**SITE PLAN REVIEW COMMITTEE  
MEETING AGENDA**

**ITEM 1**  
**Crystal Square North Retail**  
**(SP #90)**

**SPRC Agenda: First Meeting—October 26, 2017**

**SPRC Agenda: Second Meeting—November 20, 2017**

**EXISTING AND PROPOSED BUILDING  
CONSTRUCTION TYPES KEY PLAN**

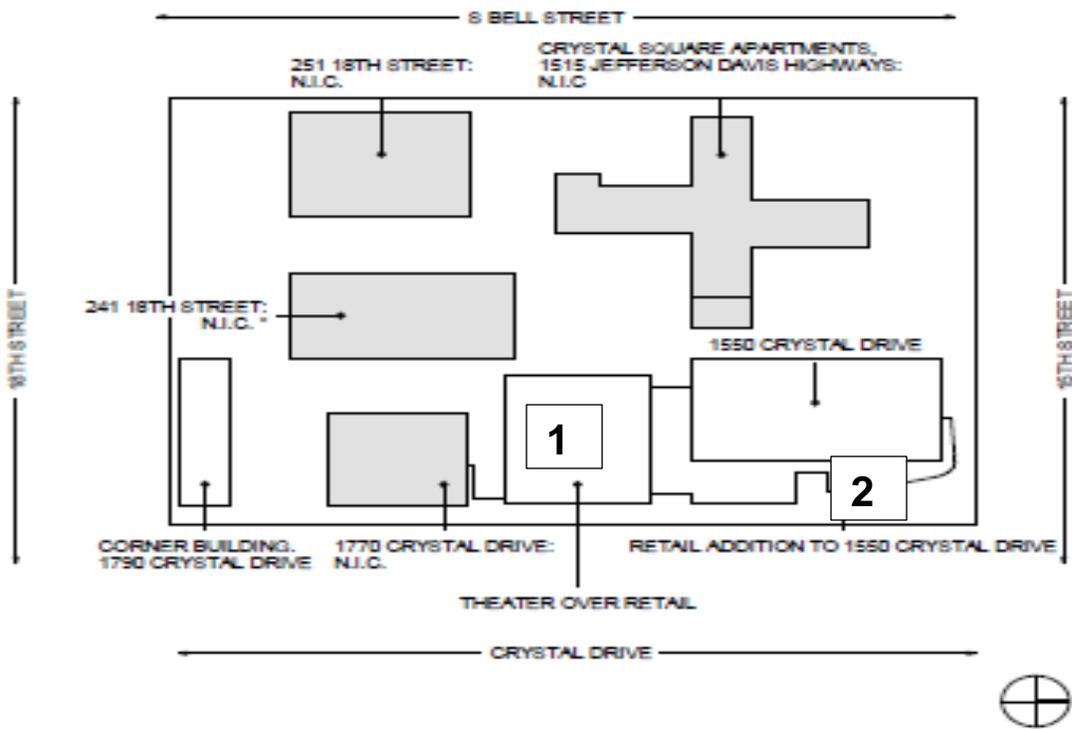
The proposed architecture generally presents a glass and dark metal contemporary retail façade with a semi-industrial look to the street rights-of-way.

Above the first level of the movie theater, glass is replaced with a decorative metal screen at the mezzanine level (additional detail of which will be needed), and gray panels on the second level. A translucent feature stretching upward two (two) stories breaks the plainness of the upper stories.

The third level of the theater is set back from the lower levels, presents a plain gray wall to Crystal Drive. The developer’s plans state “potential art” and additional information will be needed on the visibility of this wall from public rights-of-way.

Need architectural detail, material samples, views on all four sides especially views from the apartment building.
